**Marvel-Schebler Aircraft  
Carburetors LLC**

**Service Bulletin: SB-24**

**SUBJECT: MA-4-5® SERIES CARBURETORS  
EQUIPPED WITH IDLE MIXTURE SCREW  
MOUNTING PLATE**

**Figure 1**

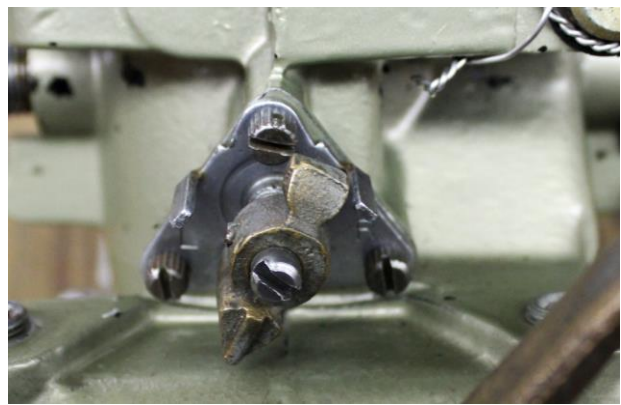
1. **Applicability:** MA-4-5® series carburetors equipped with idle mixture screw mounting plate p/n 55-524, (referred hereafter as the plate) and late style idle mixture adjusting screw as shown in Figure 1.

2. **Purpose:** To advise the industry of an acceptable rework procedure for the plate and the appearance of the properly reworked part.
3. **Discussion:** The upstanding tabs on the plate acted as limit stops for the “arrow” type idle mixture knob shown in Figure 2. However, when the late style mixture screw is installed, the tabs serve no purpose. In cases where the tabs are bent, attempts to straighten them may result in cracking at the tab’s root. Plates with bent or cracked tabs can be reworked by removing the tabs.

**Figure 2**

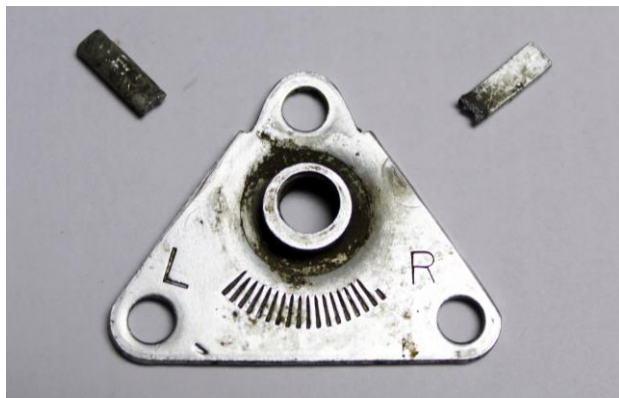
**Note:** If a carburetor is being reassembled using the arrow type idle mixture knob shown in Figure 2, a plate with both tabs intact must be used.
